AMENDMENT TO THE DRAWINGS:

REMARKS

By this Amendment, Applicant has amended claims 1, 13, and 24 to more appropriately define the invention. Claims 1-31 are pending. Applicant also proposes an amendment to the drawings for the Examiner's approval.

Fig. 1 PRIOR ART

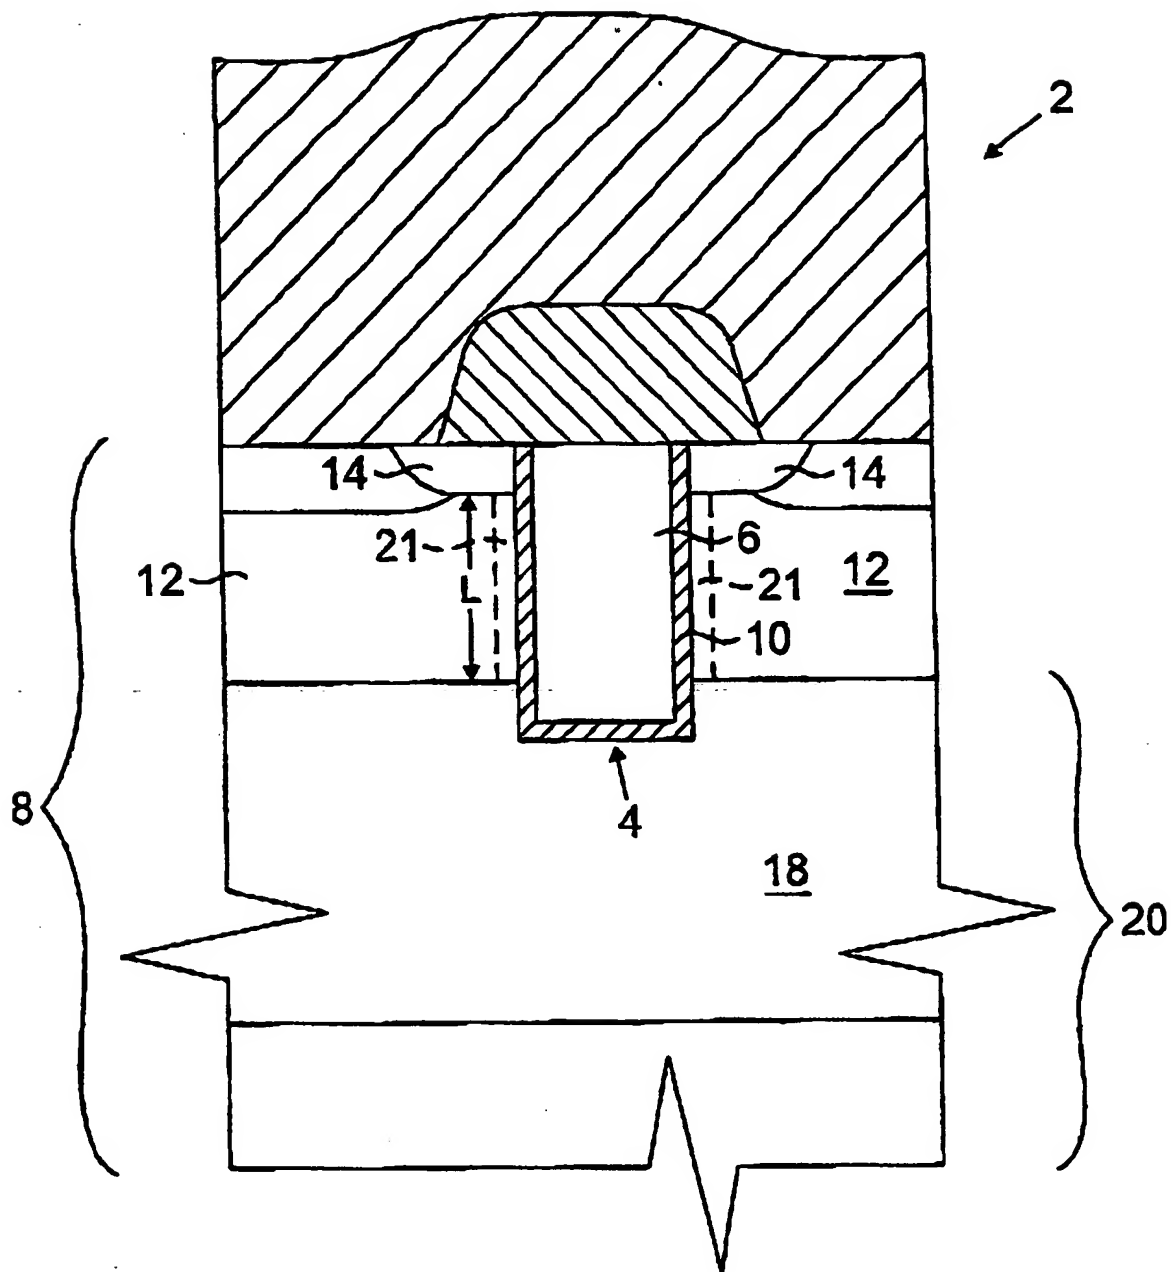
As required by the Examiner and subject to the Examiner's approval, Applicant proposes to amend the drawings by labeling Fig. 1 as "Prior Art." An annotated sheet of Fig. 1 showing the change to Fig. 1 in red and a replacement sheet of Fig. 1 incorporating the change to Fig. 1 are enclosed.

In the Office Action, the Examiner objected to the drawings and required that Fig. 1 be labeled as Prior Art; rejected claims 1-7, 9, 11-19, 22, and 23 under 35 U.S.C. § 102(b) as anticipated by Gardner et al. (U.S. Patent No. 5,780,340); rejected claims 24-31 under 35 U.S.C. § 102(b) as anticipated by Sugawara et al. (U.S. Patent No. 6,171,916); and rejected claims 8, 10, 20, and 21 under 35 U.S.C. § 103(a) as unpatentable over Gardner et al. in view of *Stanley Wolf and Richard N. Tauber, Silicon Processing for the VLSI Era*, Vol. I, Lattice Press, 1986, pp. 551-555 ("Wolf").

As the Examiner required, Applicant proposes to amend the drawings to label Fig. 1 as "Prior Art" and request that the objection to the drawings be withdrawn.
